No./Misc/---581---
HP Forest Department.

Subject :- Diversion of 3.7463 hectares of forest land in favour of Chamba Hydro Ventures, Hotel Alps Resorts, PO and Tehsil Dalhousie, District Chamba HP for the construction of Ghatore Top SHEP (4.98M.W.) within the jurisdiction of Bharmour Forest Division Distt. Chamba HP (Online Proposal No. FP/HP/HYD/155802/2022)

Ref: Minutes of the 3rd REC Meeting of 2026, REC Chandigarh, held on 12.03.2026.

DIGITAL LAND USE MAP FOR COCA SITE GIATOR TOP SHEP 4.98 MW (PROP. LAND PATCH-I 4.00 HACT. ACTUALLY REQUIRED LAND 7.50 HACT.)

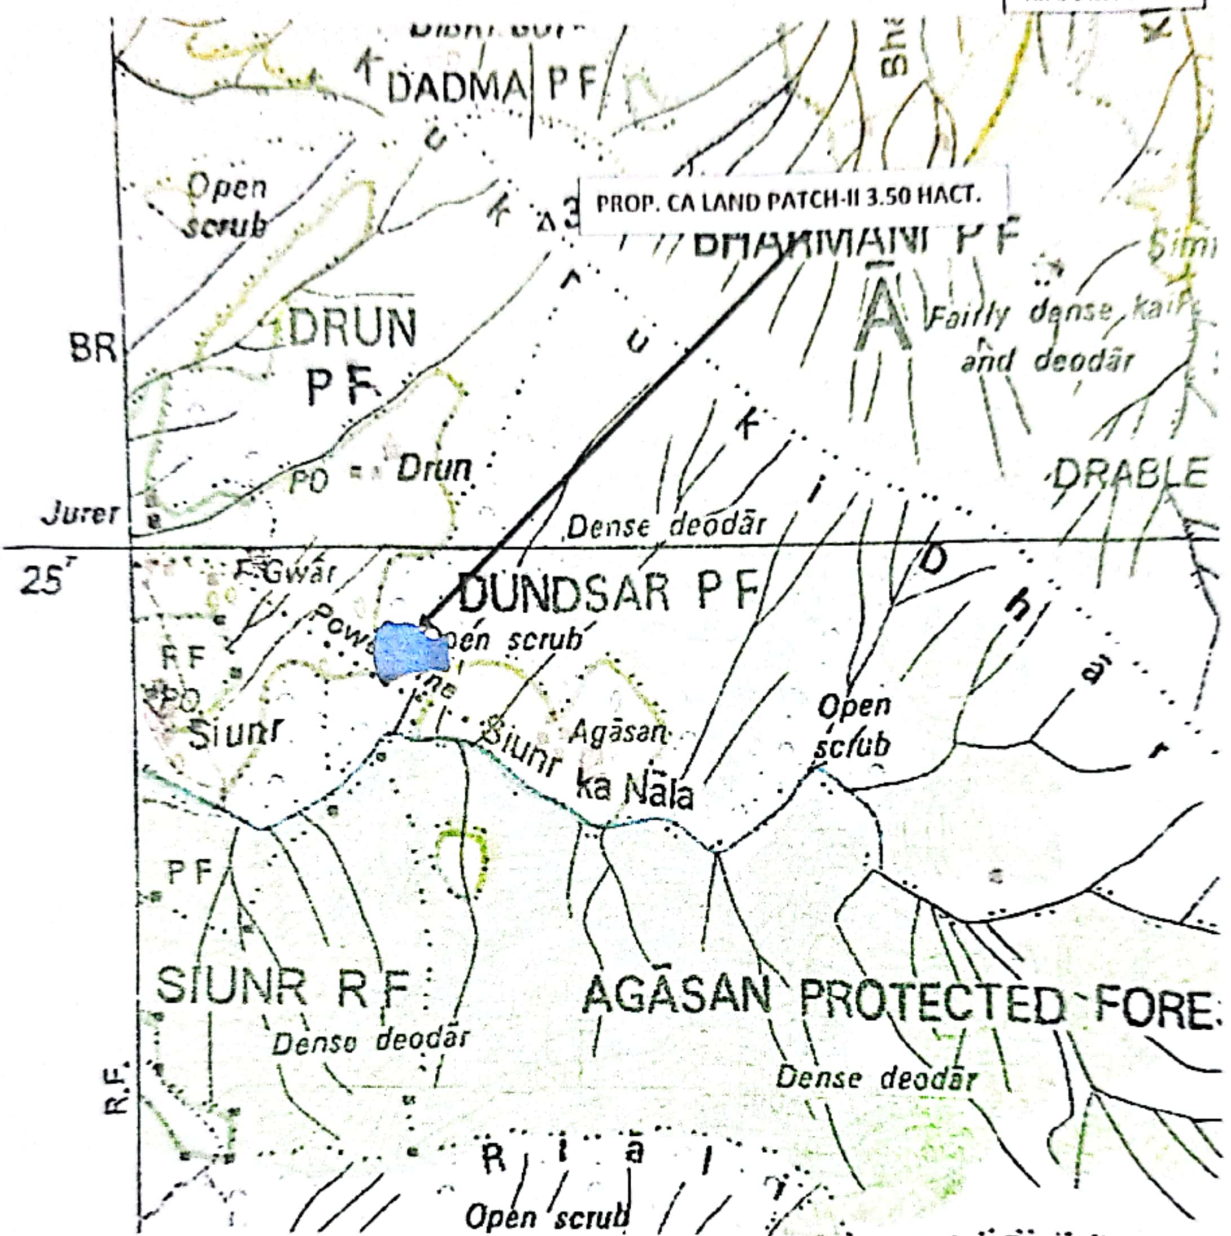
| <p>9 State Govt. need to revisit the proposed CA area for its suitability for plantation and submit the exact details of CA along with the requisite documents of the CA viz. KML, Comprehensive CA scheme, DGPS/Toposheet Map, Land suitability certificate etc. duly authenticated by DFO concerned. Also, update the details of CA in S.No-13(i), part-II.</p> | <p>The proposed Compensatory Afforestation (CA) land has been thoroughly reassessed on the ground and certified as highly suitable for plantation. All requisite authenticated documents—including the KML files, Comprehensive CA Scheme, DGPS/Toposheet Map overlays, and the Land Suitability Certificate signed by the undersigned—have been attached. Serial Number 13(i) of Part-II on the portal has been updated accordingly.</p> |

This is to certify that 03.50 hectare at DPF Khabar (CA Site) bearing Survey No./ Compartment No.52D/6D of village **Agasan**, Tehsil **Bharmour**, District **Chamba**, HP identified for Compensatory Afforestation is suitable for plantation from management point of view and is free from all sorts of encumbrances and encroachments.

This is to certify that 03.50 hectare at DPF Kuthar (CA Site) bearing Survey No./ Compartment No.52D/6/SE of village Kuthar, Tehsil Bharmour, District Chamba, HP identified for Compensatory Afforestation is suitable for plantation from management point of view and is free from all sorts of encumbrances and encroachments.

ACCESS PLAN FOR GHATOR TOP SHEP 4.98MW

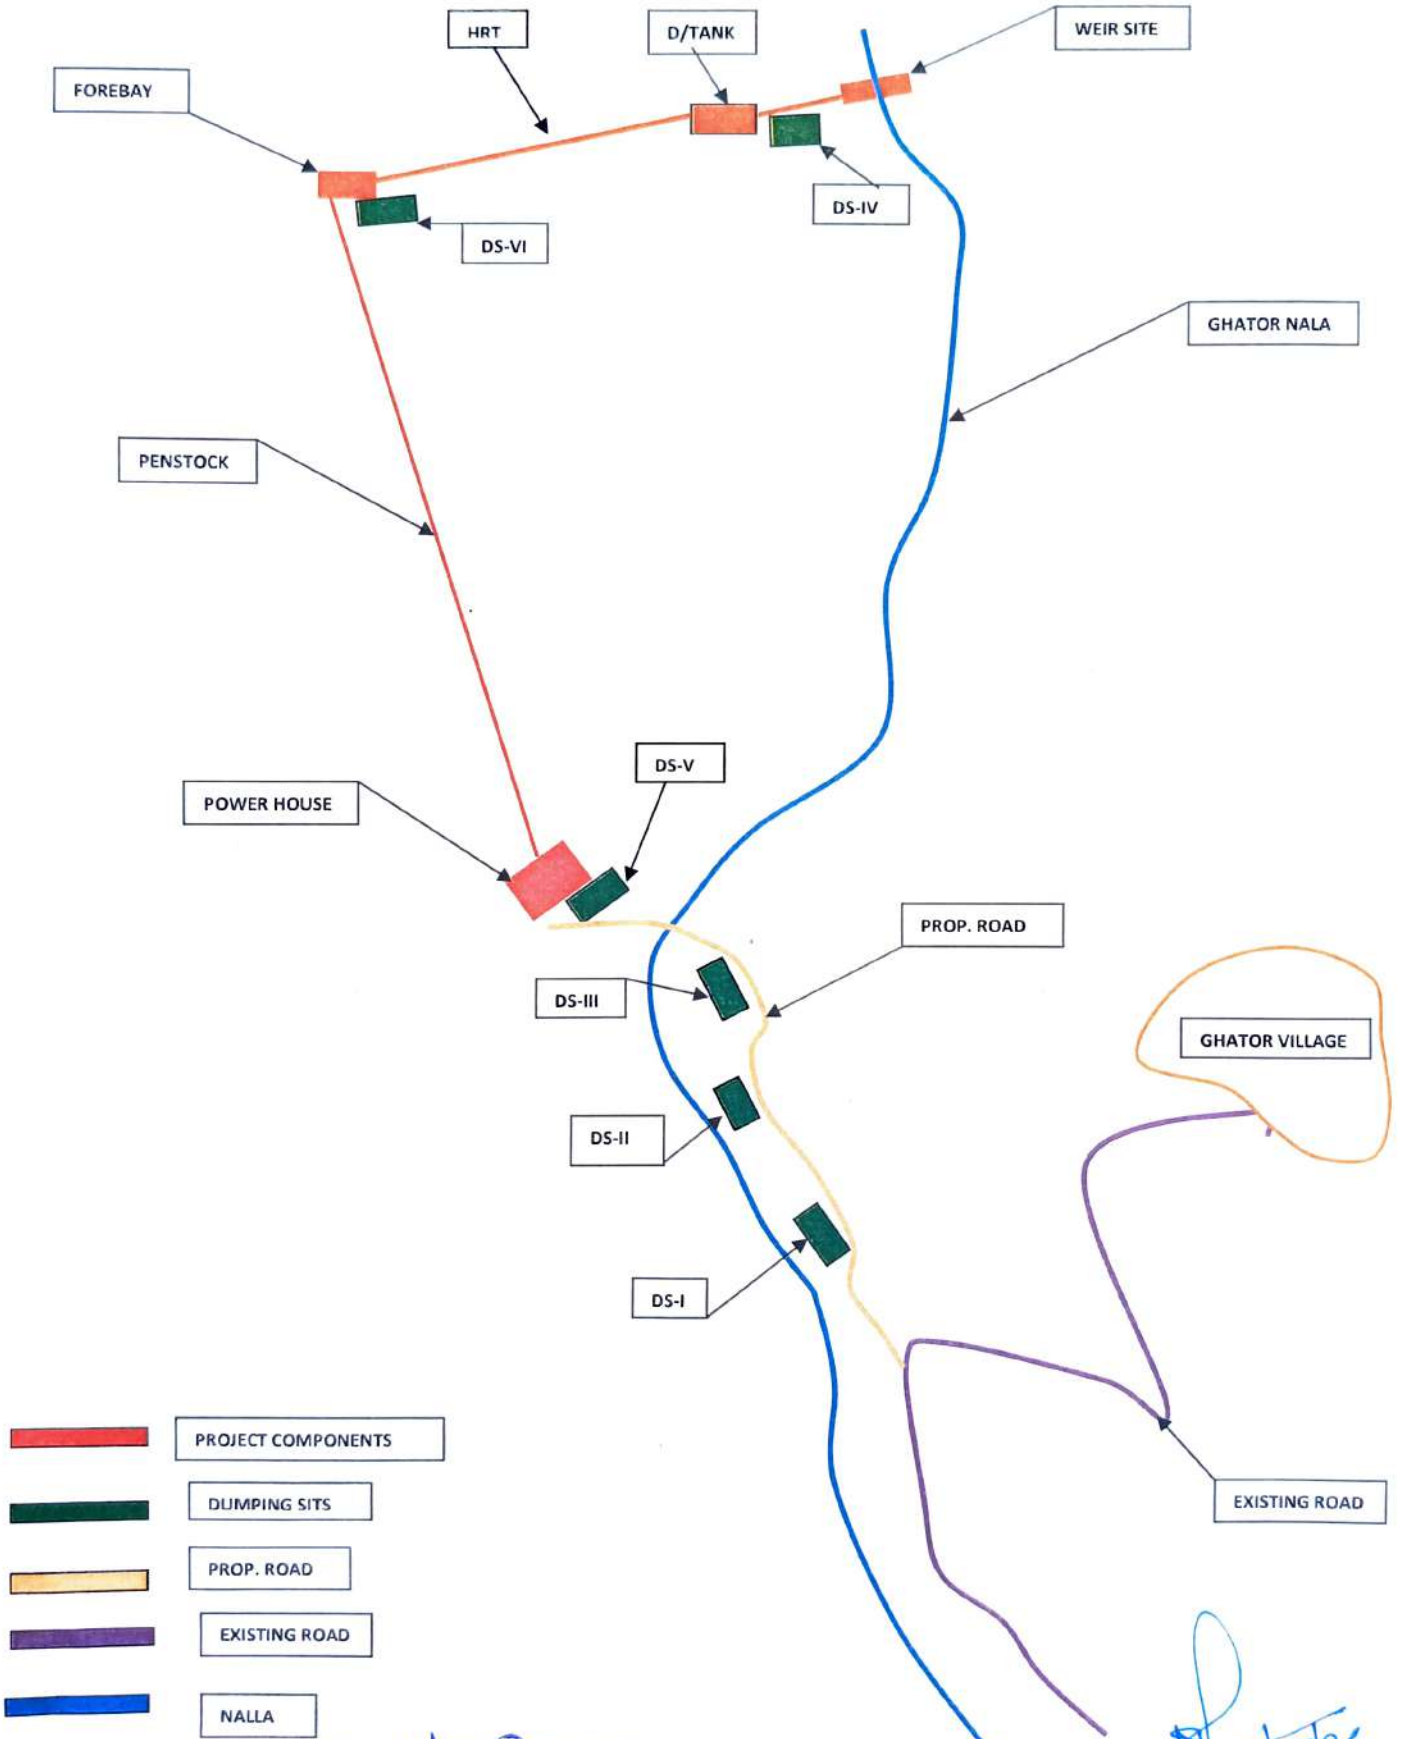
| Sr. No. | OBSERVATIONS | REPLY |
|---------|--|---|
| 2 | The State Government is also required to clarify the approach proposed for accessing the dumping sites. Details of approach road to access the proposed dumping sites need to be submitted. | The Ghatore Top SHEP is a high-head scheme optimized to minimize surface footprint. Consequently, muck handling will primarily be executed manually. Out of the six proposed sites, four (4) dumping sites lie directly parallel to core project components (the approach road and Power House), requiring no independent access infrastructure. The remaining two (2) sites are adjacent to the Weir site, HRT, Desilting Tank, and Forebay, where construction and mucking will be handled manually via localized project pathways. A comprehensive Access Plan detailing these configurations has been compiled and uploaded as supplementary data under Part-I. |

| SR. NO. | OBSERVATIONS | REPLY |
|---------|--|--|
| 2. | The State Government is also required to clarify the approach proposed for accessing the dumping sites. Details of approach road to access the proposed dumping sites need to be submitted. | In this regard it is submitted that the Ghator Top small Hydro Power Project (4.98MW) is a high head scheme in which small components has been proposed by adopting the technical specifications. Most of the mucking will be done manually. All the Dumping sites proposed are lying with the |

| | | <p>the muck Dumping out of which IV Dumping sites are along the proposed Project components i.e road and Power House etc. So there is no need of specific access to these Dumping sites. Whereas the remaining II Dumping sites are accommodating those components where all the work will be executed manually and mucking will also be done manually and these Dumping sites are also adjoining the components i.e W/Site, HRT, D-Tank and forebay etc. where no need of specific access. The access plan to the Dumping sites has been attached here for your ready reference Please.</p> |

GEO-REFERENCE MAP ON SOI SHEET 52-D-7 (1:50000) FOR 3.7463 HECT. OF FOREST LAND TO BE DIVERTED FOR CONSTRUCTION OF GHATOR TOP SHEP(4.98MW)
 PROJECT:- GHATOR TOP SHEP(4.98MW)
 NAME OF APPLICANT:- CHAMBA HYDRO VENTURES
 NAME OF FOREST DIVISION:- BHARMOUR
 SOI SHEET NO. 52-D/7

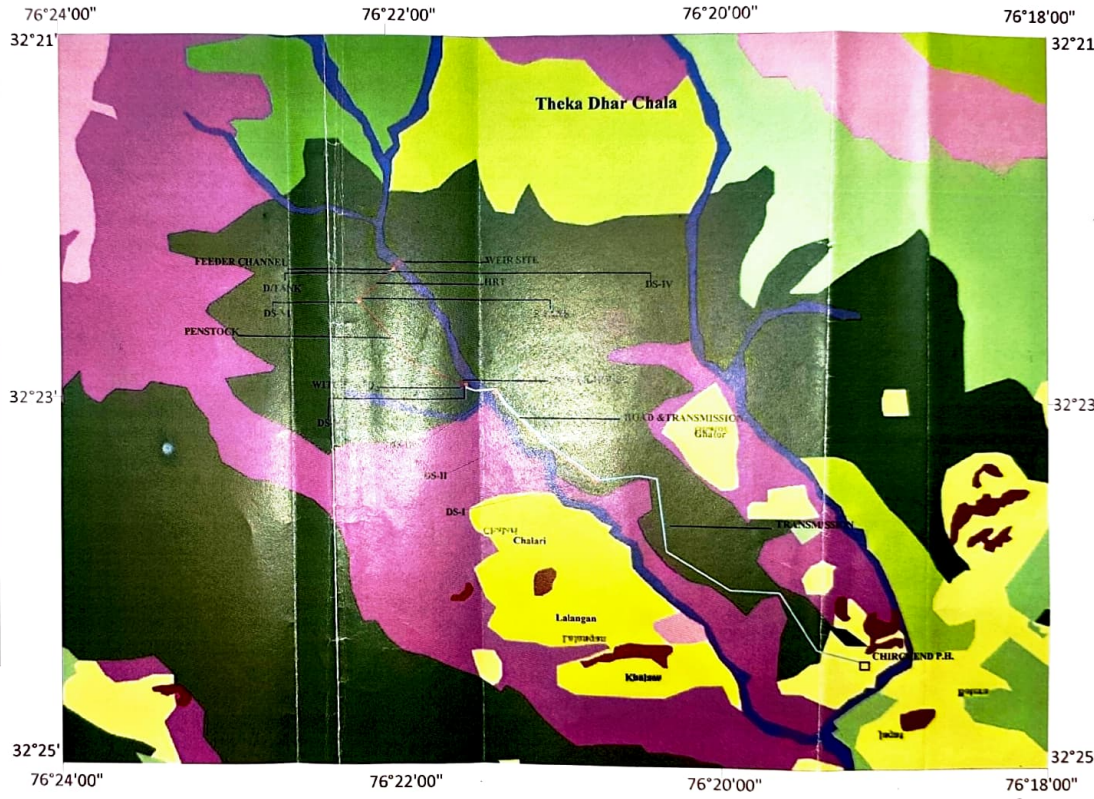
| 8 | 8. State Govt. needs to submit the revised DGPS map of the diversion area in legible format showing lat/long of the components. | A high-resolution, legible Differential GPS (DGPS) map, distinctly demarcating the latitudes, longitudes, and boundary pillars of all critical project components, has been uploaded under Part-I by the User Agency. |

| 8. | State Govt. needs to submit the revised DGPS map of the diversion area in legible format showing lat/ long of the components. | The DGPS map of the diversion area has been uploaded in legible format. |
